**Submission on National Electricity Amendment (Generator ramp rates and dispatch inflexibility in bidding) Rule 2014**

## **AEMO Submission in response to AEMC Draft Determination: National Electricity Amendment (Generator ramp rates and dispatch inflexibility in bidding) Rule 2014**

**Figure 1 – South Australia Hot Water Demand Pickup**

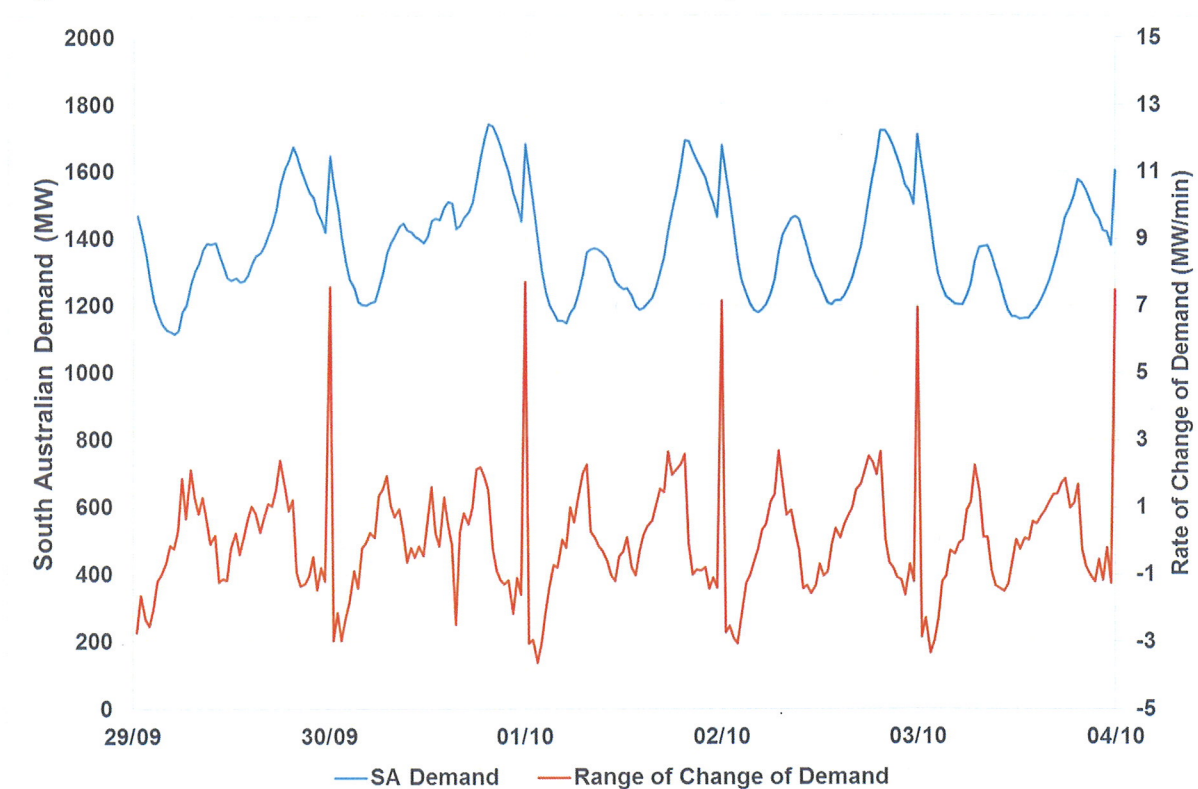
Figure 1 shows the impact of the hot water pickup during mild weather conditions (week ending 4 October 2014) on the South Australia demand and the required ramp rate to maintain power system security within South Australia alone.

AEMO has not attempted to quantify the impact of the draft rule on the market's ability to deliver a secure power system. However, the draft rule would reduce the available ramping capability under these conditions to a greater extent than the originally proposed rule.
